Colorado Springs Utilities

**Subject: South Raw Water Pipeline 3 (S3) Construction Restoration, Southern Delivery System (SDS), 1041 Permit No. 2008-002**

**SUBJECT:** Responses to Total Terrain's Site Review of S-3 Revegetation and Erosion Control, Dated October 1, 2012

**Attachment B**  
**Walker Ranches Cross-sections**

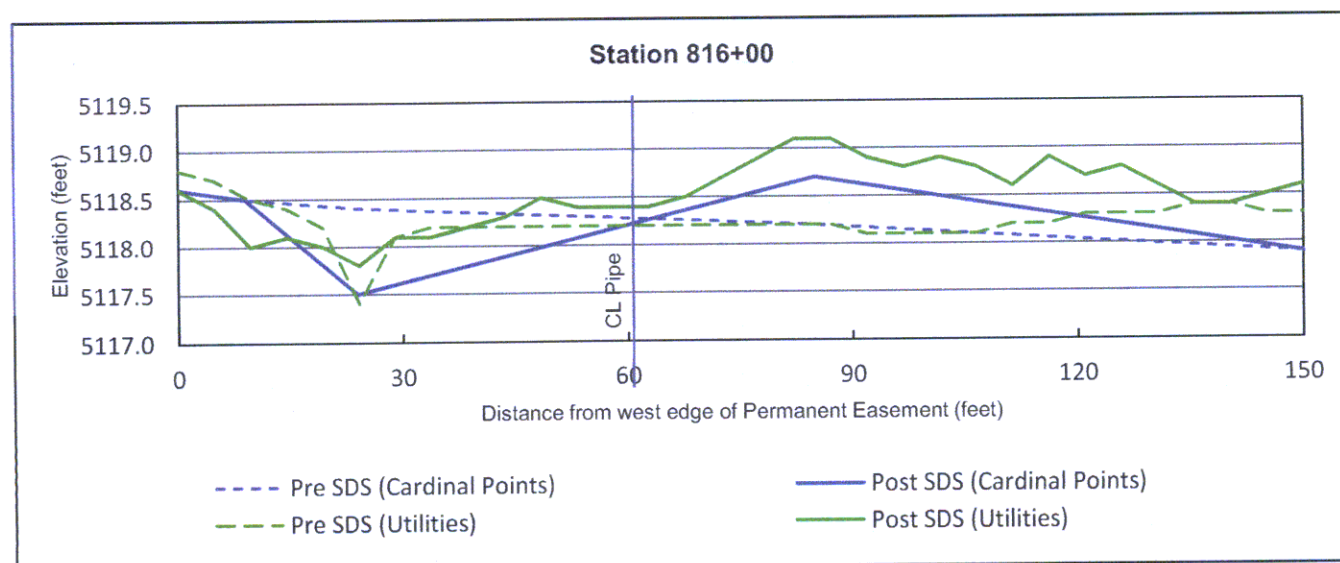
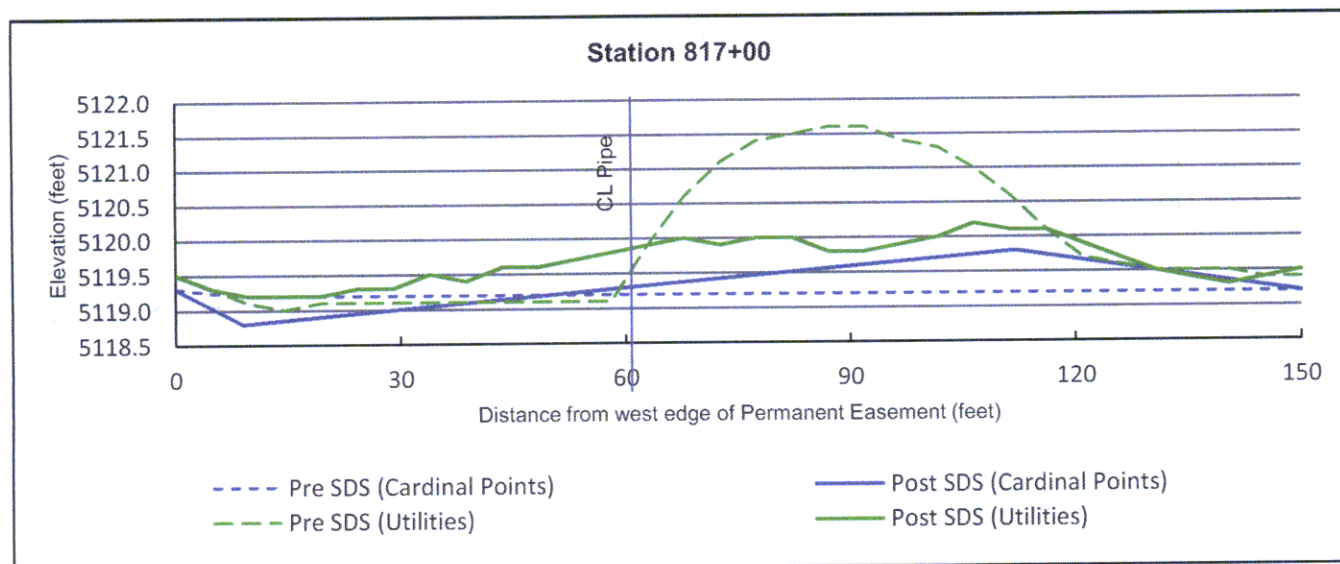
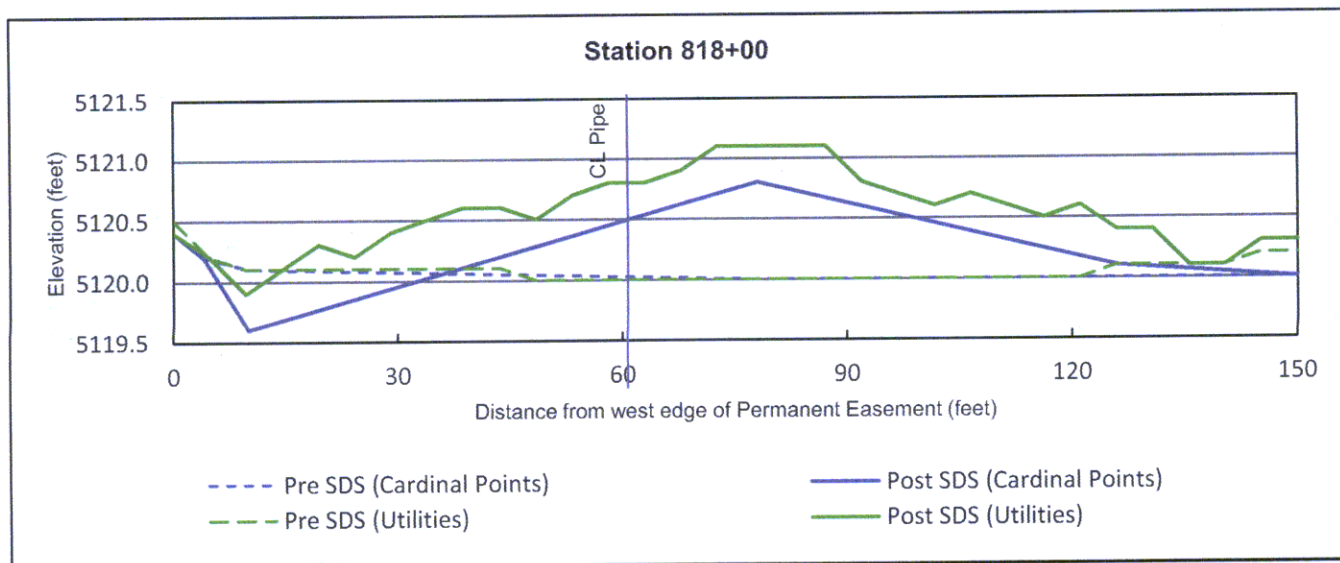
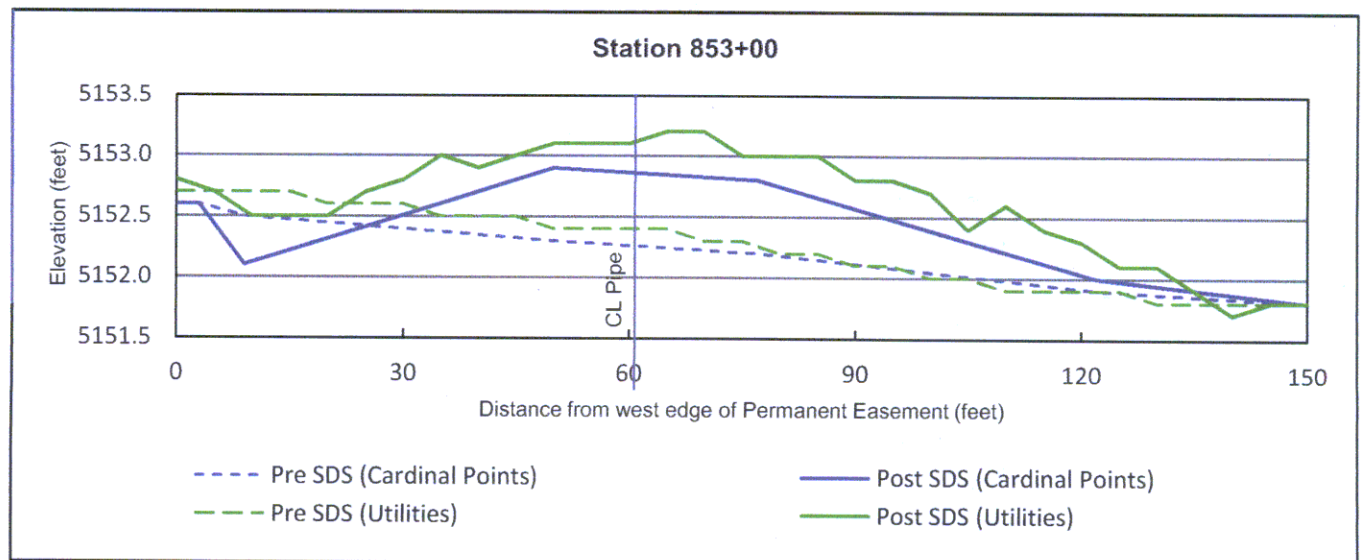
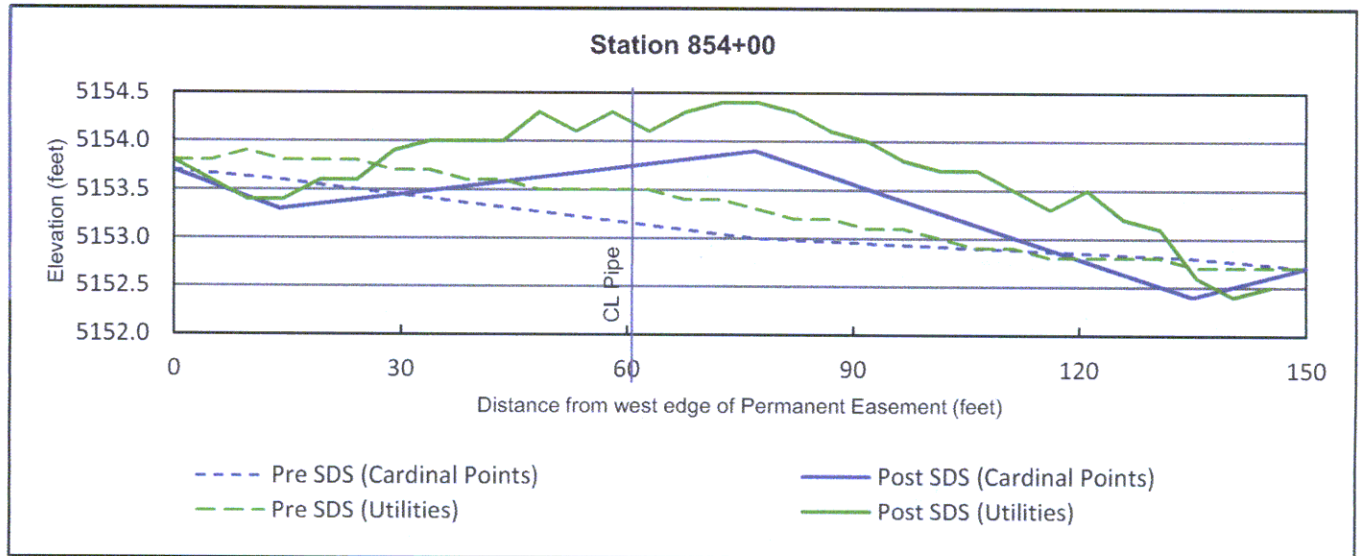
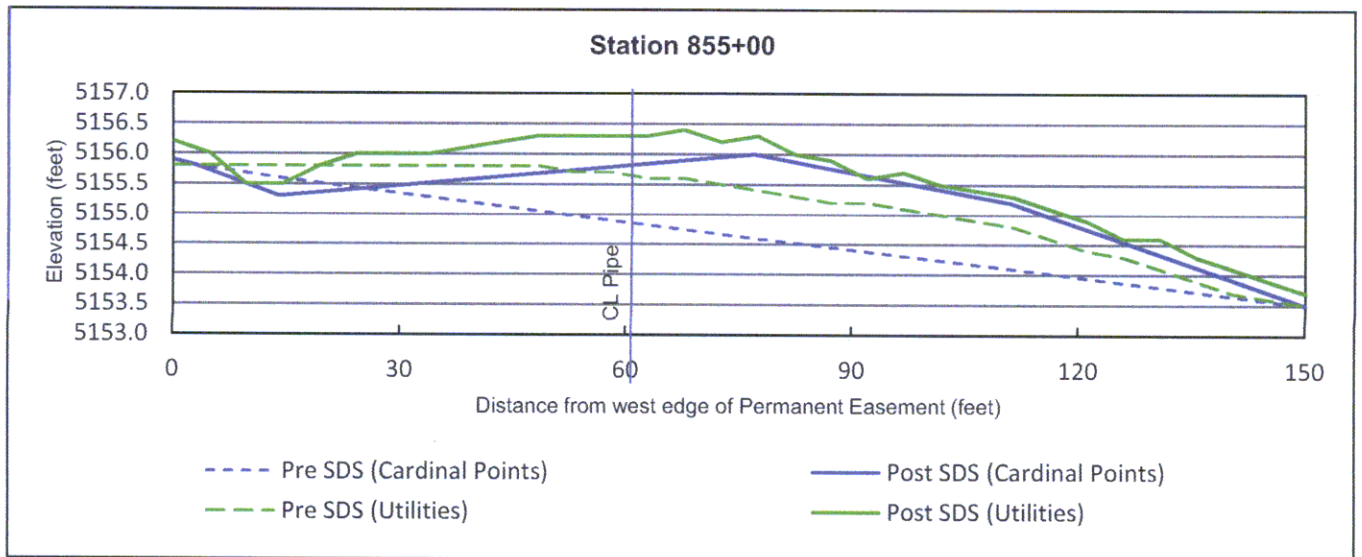
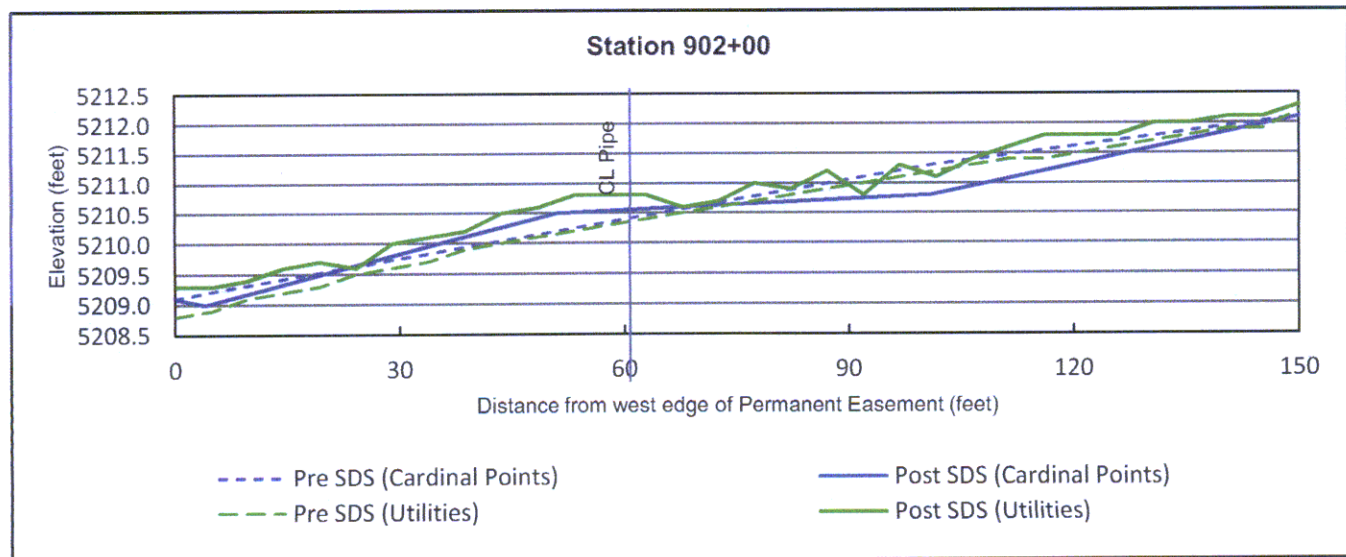
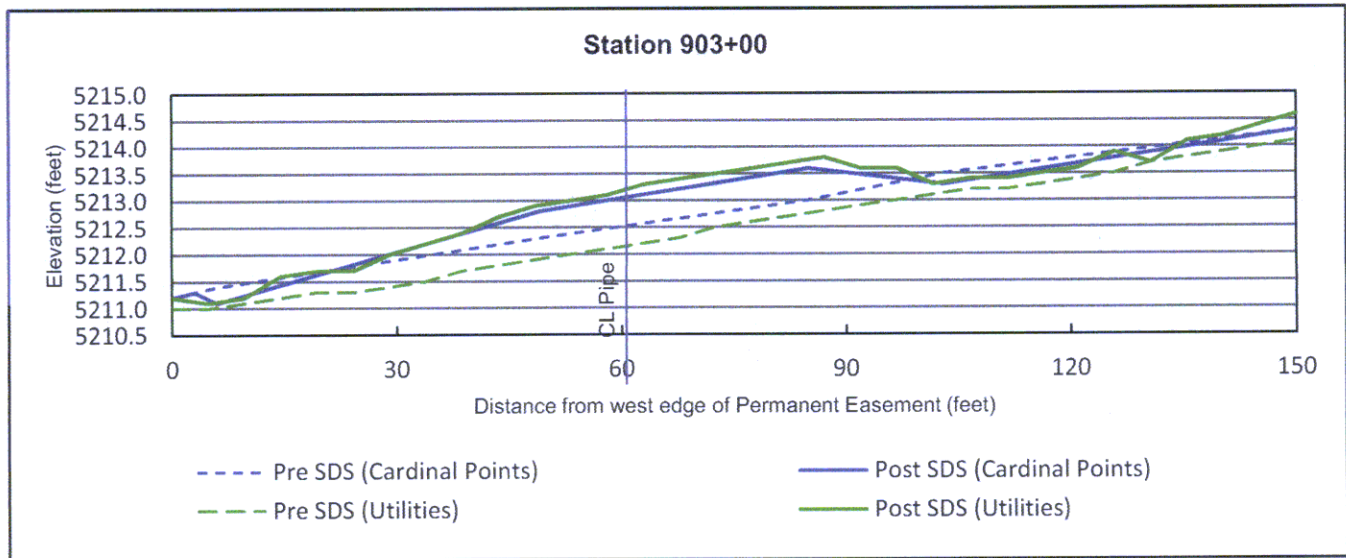
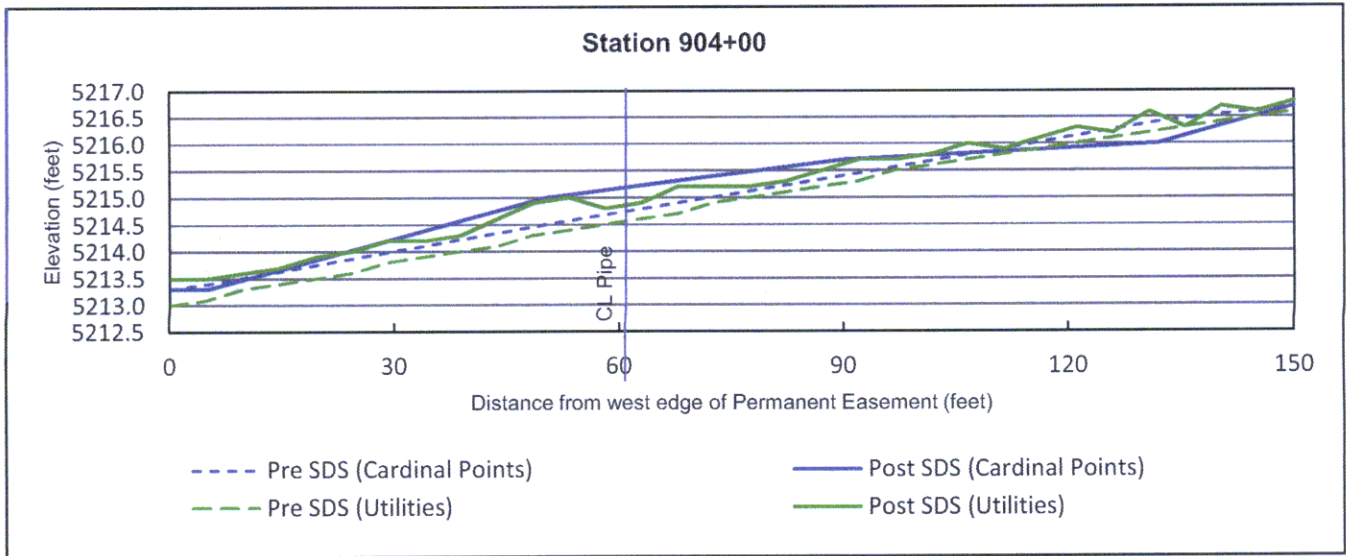
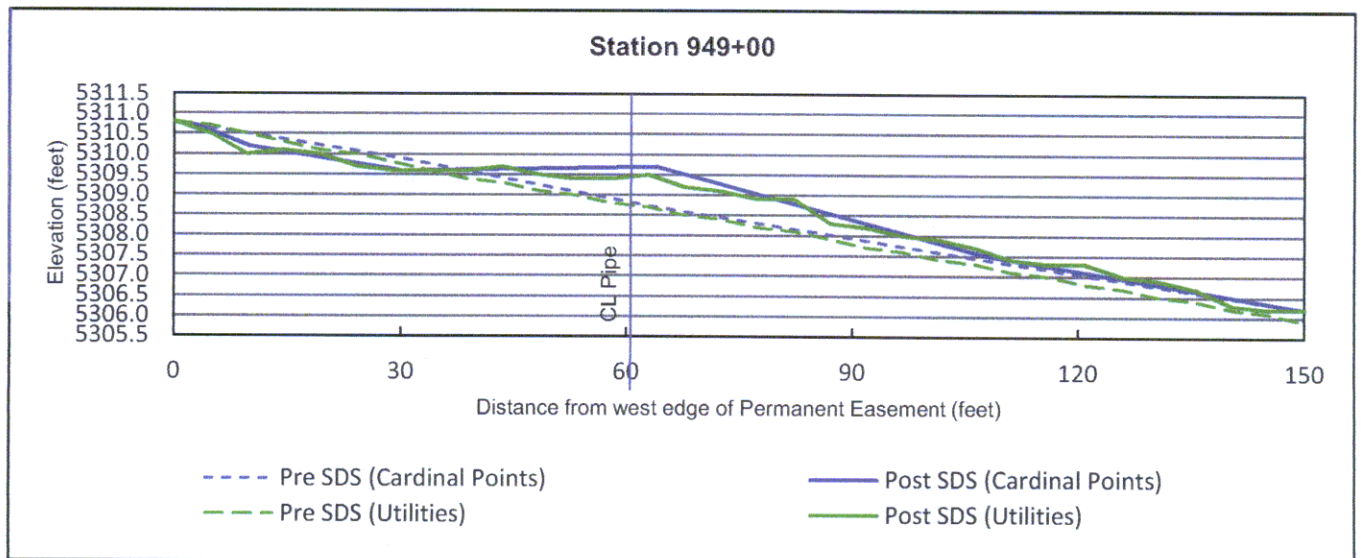
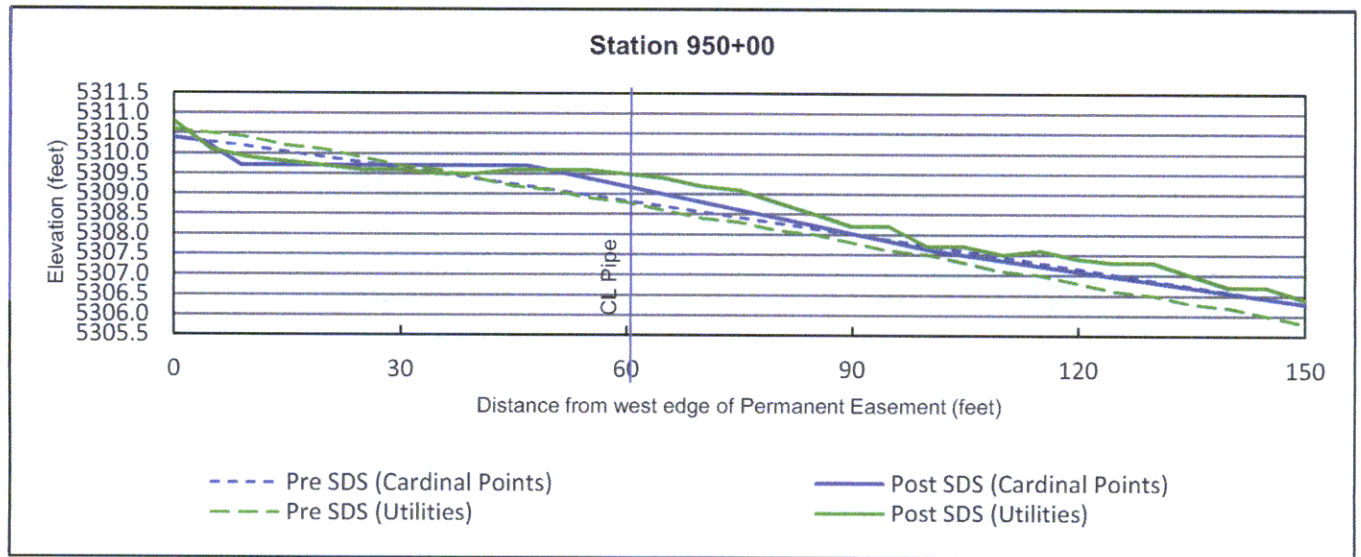
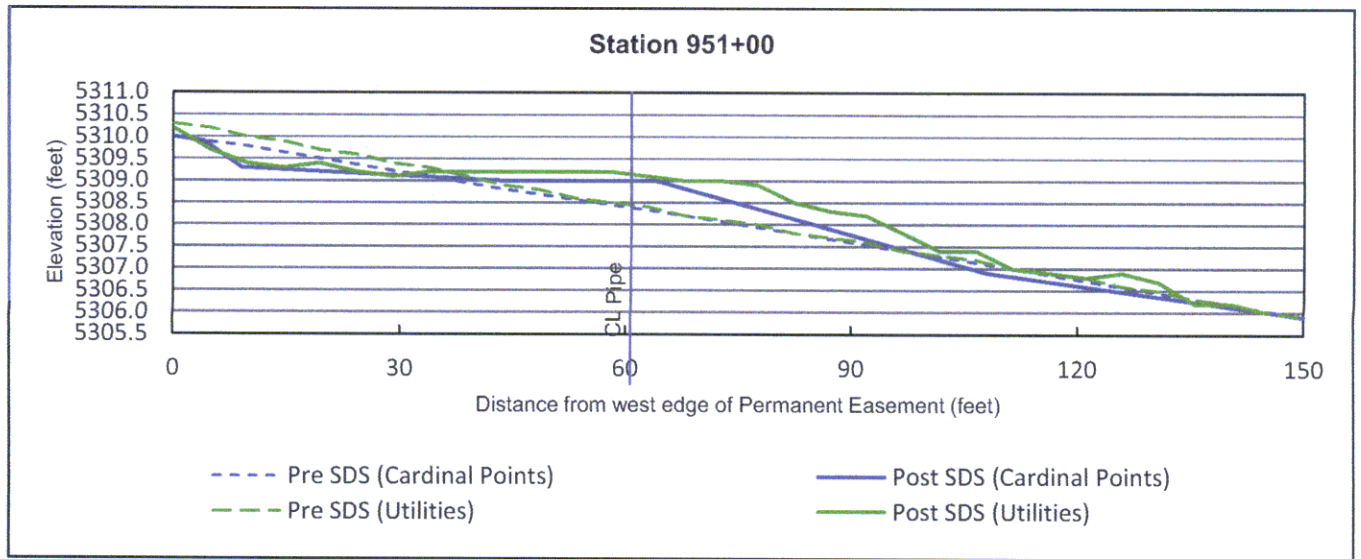
On October 2, 2012, Cardinal Points Surveying, Inc. collected cross-sectional surveys at 19 locations along the S3 alignment within Walker Ranch. Pre-construction grade was represented by a straight line between survey points measured after construction and at the outer edges of the construction area. Post-construction grade was determined by survey of about two to five points between the outer edges of the construction area for each cross-section.

Cardinal Points' data were compared to co-located (by pipeline station number) SDS pre-construction and post-construction survey data described above. Figures of those comparisons are provided in Attachment B. Cardinal Points' pre-construction cross-sections were inconsistent with the SDS pre-construction survey except where the construction area approximated a plane. Elevation variation across the construction area was, as would be expected based on the Cardinal Points' survey approach and timing, absent from their data. Consequently, the Cardinal Points pre-construction cross-sections are unsuitable for evaluating post-construction grading. Cardinal Points' post-construction cross-sections were similar, though with less resolution, to cross-sections prepared using the SDS post-construction data.
